CAMDEN GOODS YARD

BUILDING A
PLANNING CONDITION 26 REPORT - REV A

REDUCTION IN FACADE DEPTH

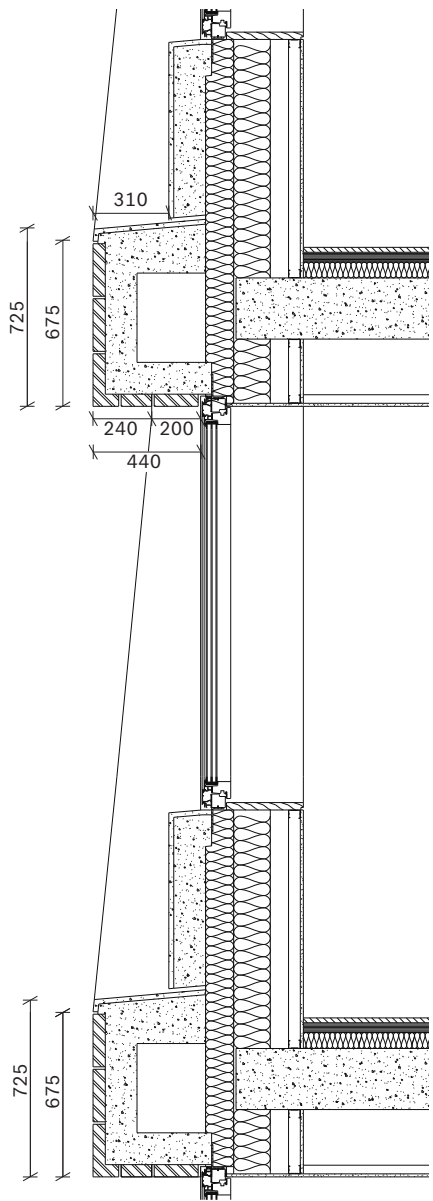
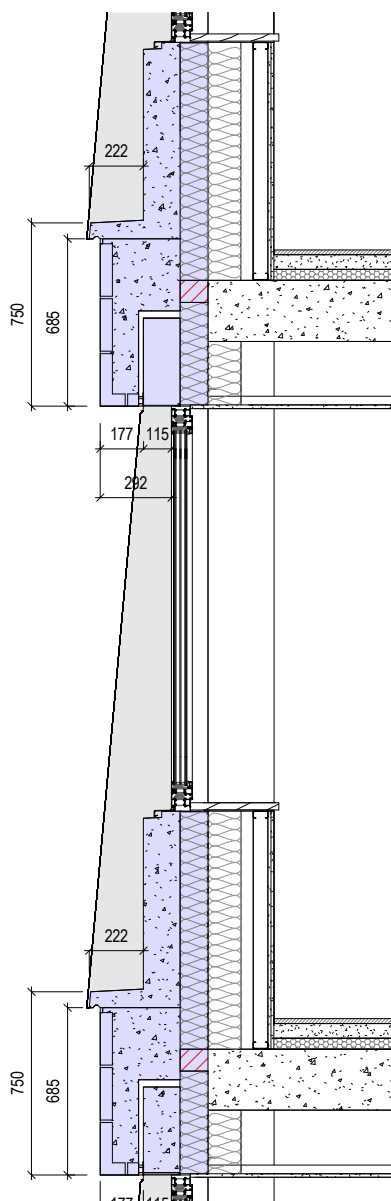
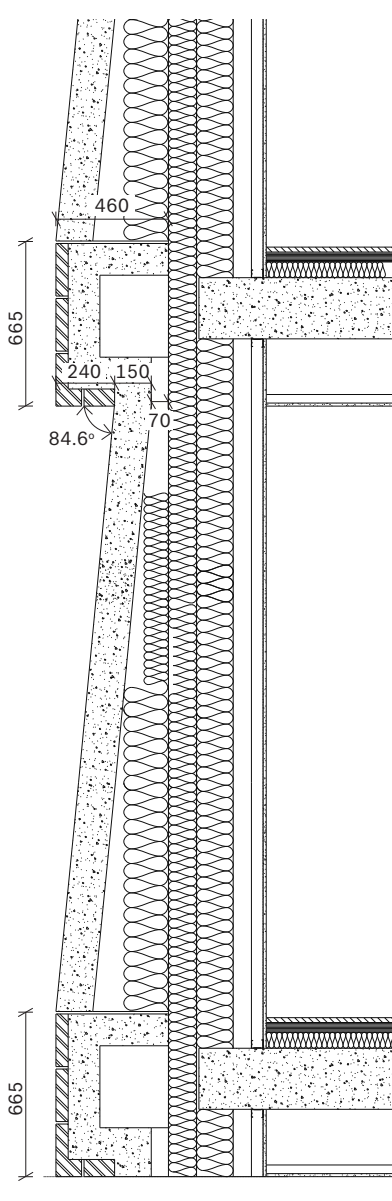
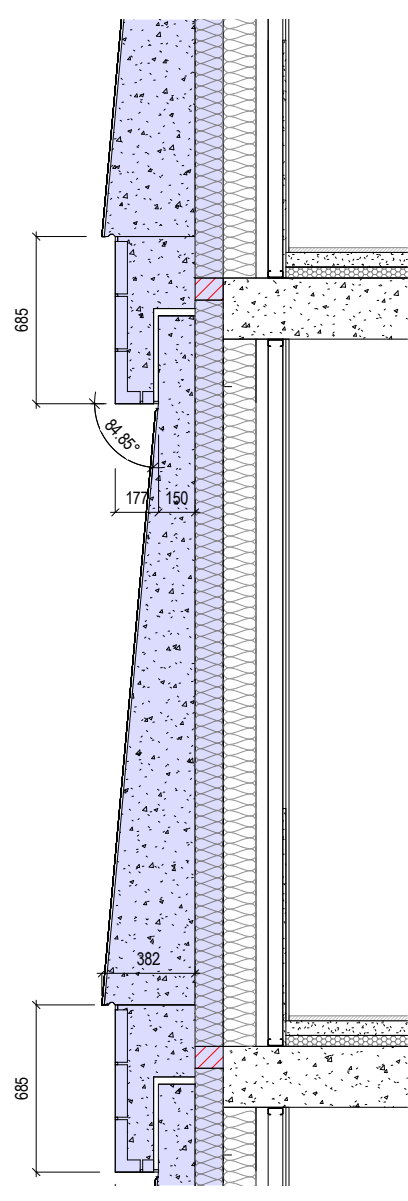
- KEY UPDATES:
- Slimming of facade depth to reduce concrete volume
 - Introduction of cill projections to reduce staining
 - Improved integration of soffit vents at window heads
 - Change to panel subdivision to improve buildability and robustness
 - Introduction of micro-flutes to piers to add interest and conceal joints
 - Other minor refinements as documented

Reducing the panel depths will reduce the amount of concrete and reinforcement required to make the units. The proposal will reduce the amount of concrete by 135m3 and 337 tonnes, reducing lorry deliveries to site by between 15-20 loads.

To reduce the risk of staining whilst maximising the pier depths, it is proposed to introduce a projecting cill below the windows, with the bottom edge of the piers also aligning with these to create a continuous robust detail.

SECTION DETAIL THROUGH SOFFIT PANEL

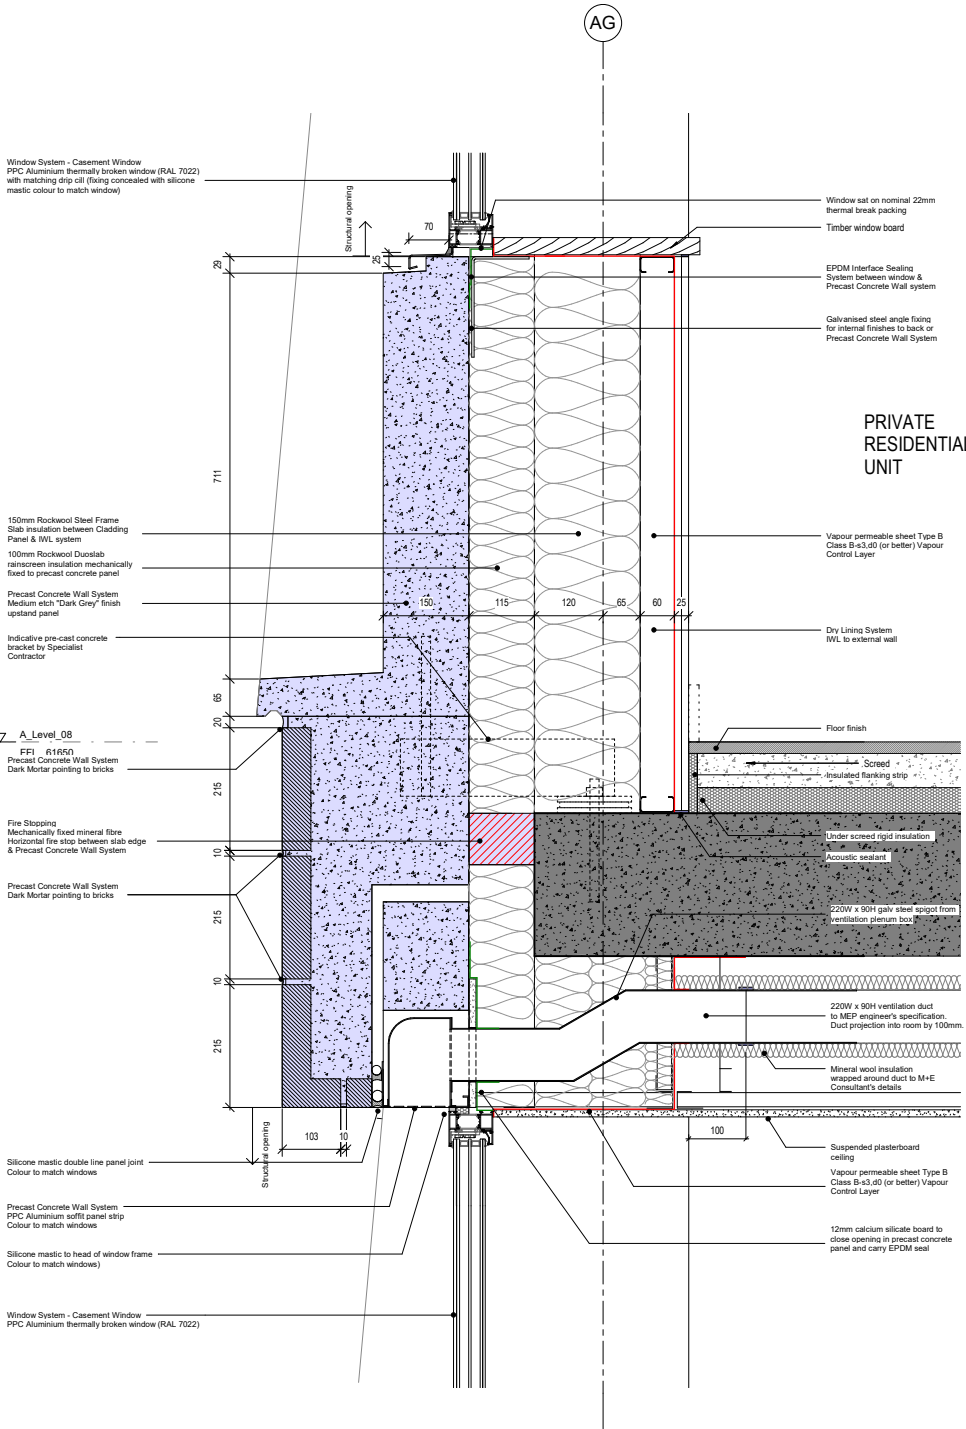
To better integrate the required vents in the soffits at the window heads, it is proposed to contain the vents within a metal soffit panel that spans from pier to pier and sits within the depth of the head of the piers, thus retaining a c.160mm brick return to the soffits.

This metal soffit panel with integrated vents will match the finish of the window frames. We believe this will result in a neater and more discreet detail, where the vents read as being a part of the window system.

The dark grey finish of the soffit panels will also closely match the brick tone, so will retain the overall appearance of a deeply recessed window whilst providing a neater and more integrated solution.

Proposed precast sample with light etch finish and no flutes for Ground Floor piers

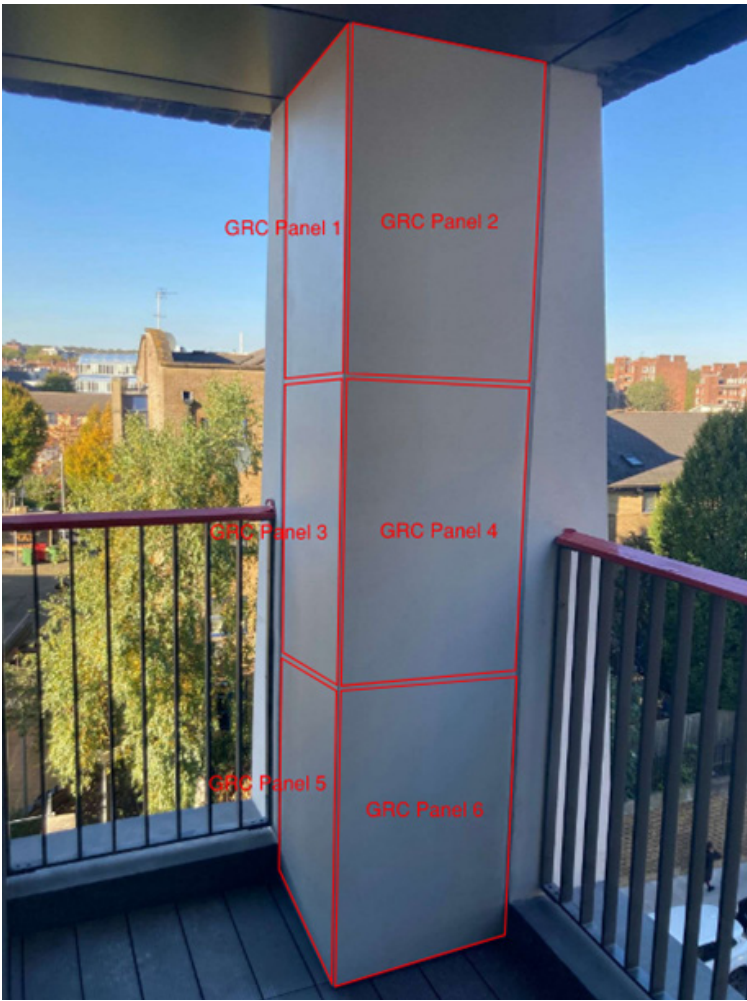
The original planning application noted the use of a larger exposed aggregate to the ground floor piers. The requirement for this detail was omitted in the 2020 S73 application, as captured in the approved 2020 DAS Addendum.

This omission followed detailed discussions with the facade contractor and sample testing, where it became apparent that the exposure of more aggregate in these large single cast piers at ground floor level will dramatically increase the risk of a noticeable varied aggregate size across the same panel, due to the natural distribution of aggregates that occurs on the surface or L-shaped precast and panels with returns/ reveals.

Due to the concrete settling under gravity and the compaction process needed to ensure concrete strength and durability, the larger/heavier pieces of stone will always be attracted to the base of the mould, and therefore, the cast face of the base mould surface will have a higher percentage of large aggregate visible.

This will be more prominent in concrete which has been honed or deeply etched to reveal the larger pieces of stone. Where a lighter depth of etching is carried out, and less of the larger stone overall is exposed, the different faces of the panels will generally be more consistent.

As a result, we propose a light etching of these ground floor piers to expose some aggregate whilst not accentuating this uneven distribution, achieving an improved visual appearance. With the introduction of the micro flutes and heavier etch to the upper piers and maintaining a heavier flat surface to the ground floor piers, we are able to retain a subtle difference between these piers as per the original design intent.

MULTIPLE GRC PANELS ARRANGEMENT ON BALCONY REVEAL

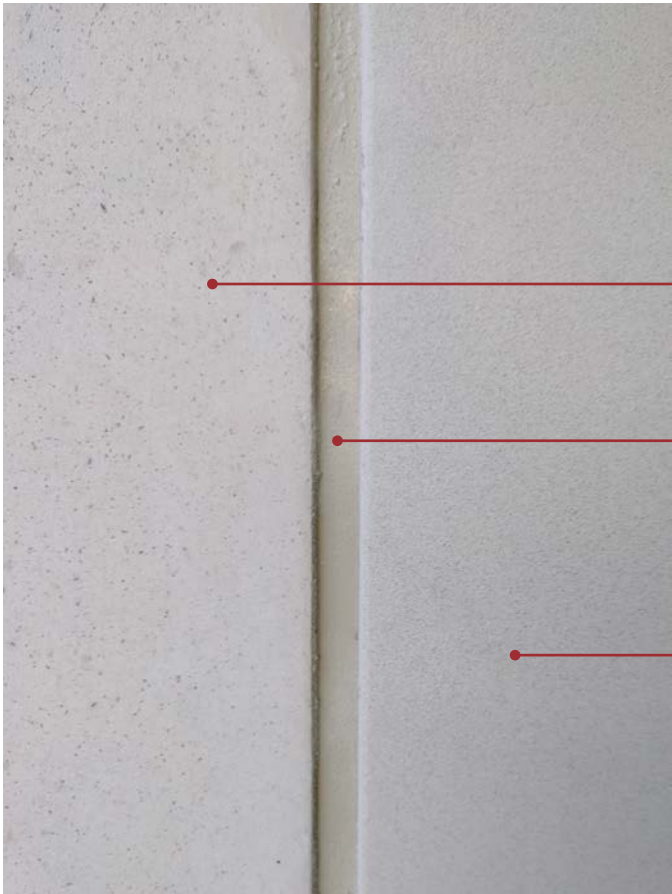
Consented GRC proposal: Concerns raised by specialist manufacturers are as outlined below:

1. If the GRC panel was to be manufactured as a single panel as originally envisaged the weight of each panel would be in the region of 350kg. Within the confined spatial limitations of the balcony we would not be able to transport, lift or install a GRC panel of such a weight practically or from a health & safety (CDM) perspective.

2. The conclusion regarding the weight limitations of the panel means the panels would need to be designed and split up into multiple panels weighing between 50-60kg to comply with CDM and allow for them to be physically transported and lifted into place. As per the images below the GRC panels would need to be split into 6 vertical panels for the column cladding and 5 horizontal panels for the main balcony reveal panel. This panel arrangement has been considered as both visually poor and unsightly, leading to the cladding looking more like tiling rather than a full height cladding panel as originally envisaged. Marked up photos reflect the GRC panel jointing strategy.

3. GRC is a material which could be vulnerable to damage and staining with limitations in being able to repair or re vulnerable balcony locations. This is a concern in the future from both a maintenance perspective as well as from a visual perspective where-by panels could look a complete mismatch to each other in years to come.

ALTERNATIVE TEXTURED PPC CLADDING

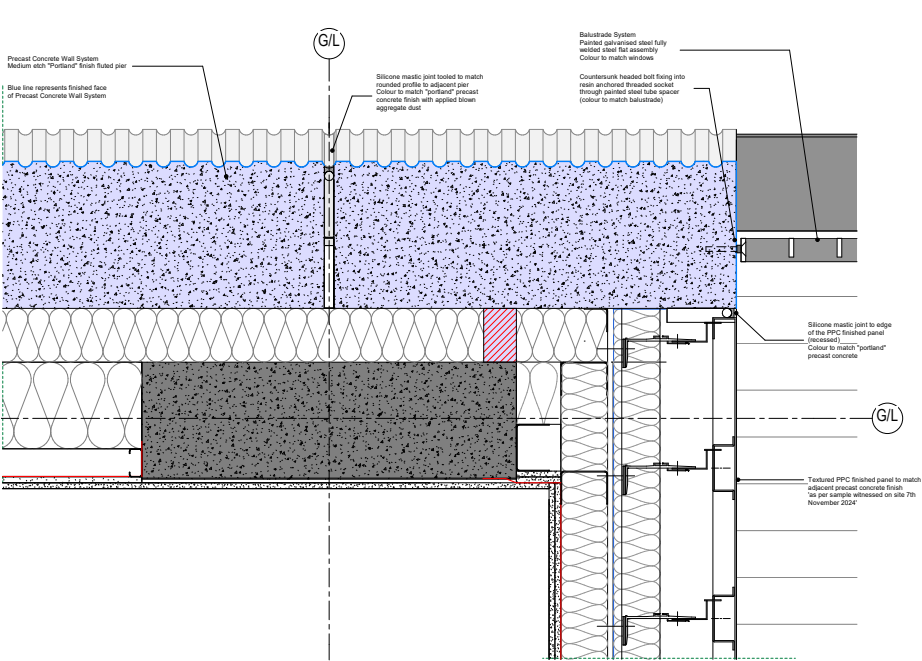
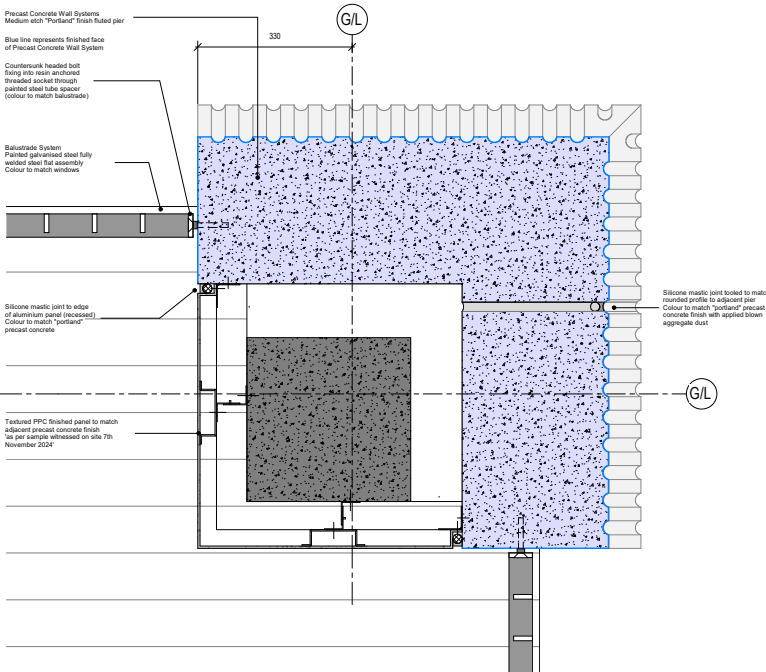
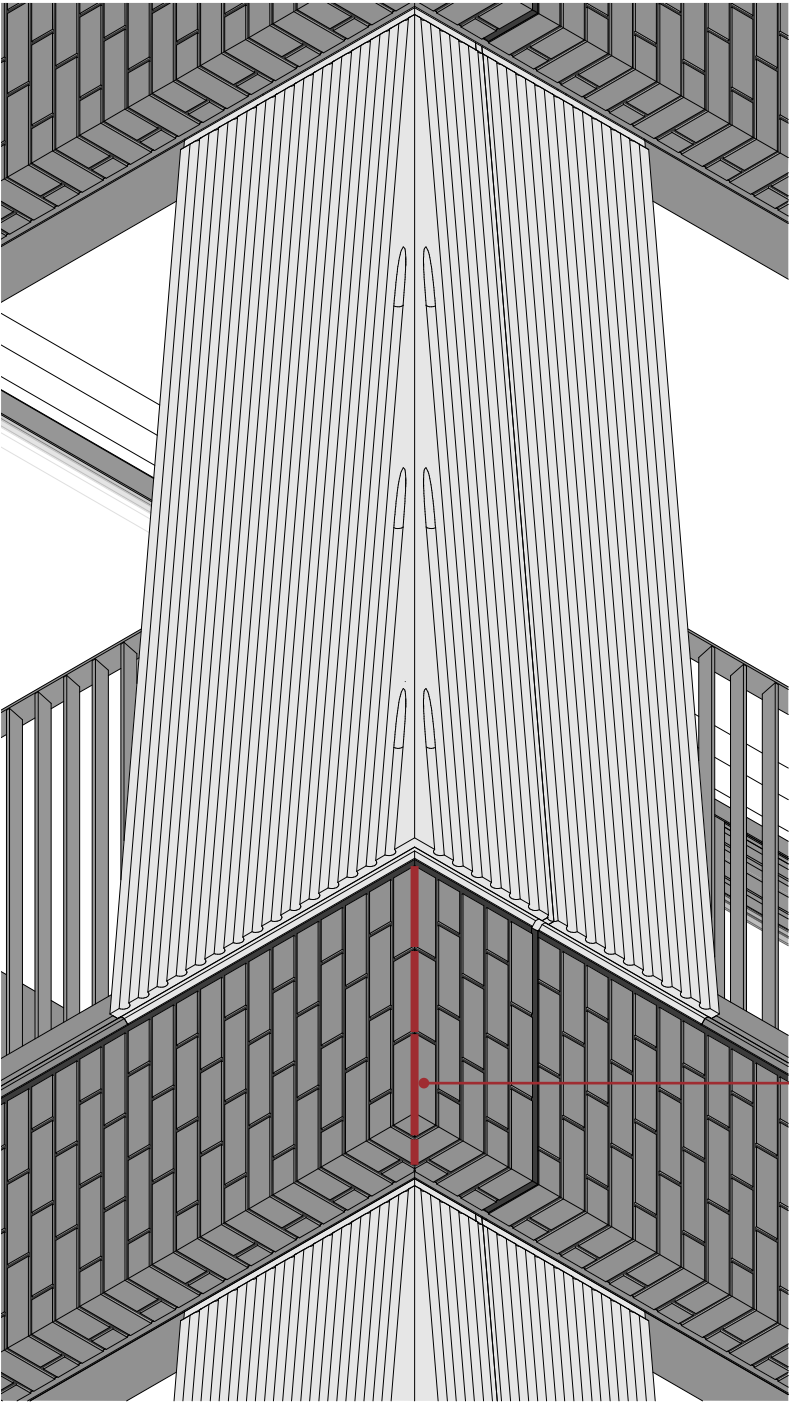
During our visit on site with Kevin we viewed the alternative Textured PPC cladding proposal looking up at it up from the street and from within the balcony. What was evident and agreed on site was the locations of the proposed cladding amendments are in discreet and partially hidden locations within the balconies. Some of the key observations regarding the alternative textured PPC cladding are as follows:

1. The alternative proposed panel offers a high-quality grained texture which will remain the same long term in terms of quality and appearance. The proposal is a near perfect match adjacent to the precast concrete panel finish.
2. As illustrated in the photo what was presented onsite was a vertical 2 panel arrangement. Having discussed this on site with Kevin and since discussed with a manufacturer we are pleased to confirm the overall panel can be delivered in a single panel as per the original vision.
3. The fundamental reason for moving away from GRC is primarily driven by the increased number of prominent joints, which are both undesirable and not in keeping with the architectural vision.

BRICK CORNER DETAIL

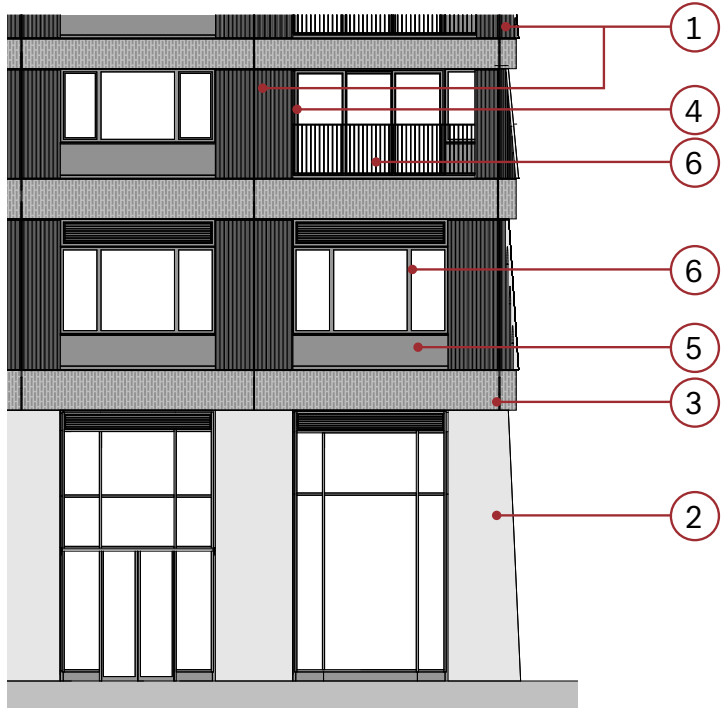
The planning scheme requires a number of special brick shapes to achieve the outer corner detailing of the brick faced precast spandrels at each storey level of the facade.

These could be cast as special square shaped corner bricks, but these would have to be fabricated in a separate batch from the main brick stock. This will introduce a significant risk of the specials not matching the visual appearance of the rest of the bricks, which would be detrimental to the visual appearance of the completed brick faced precast elements.

Instead it is proposed to use a specialist to fabricate cut and glued brick specials from the main brick stock, ensuring an exact visual match with all the adjacent brickwork.

Through multiple sample tests we have reached a satisfactory end result where the glued joints will be imperceptible in the finished brick faced precast elements. This is achieved with the accuracy of the cutting of the bricks and the use of an adhesive that matches the brick colour, which is then covered with brick dust that dries into the adhesive to create a surface finish that very closely matches the finished faces of the brick.
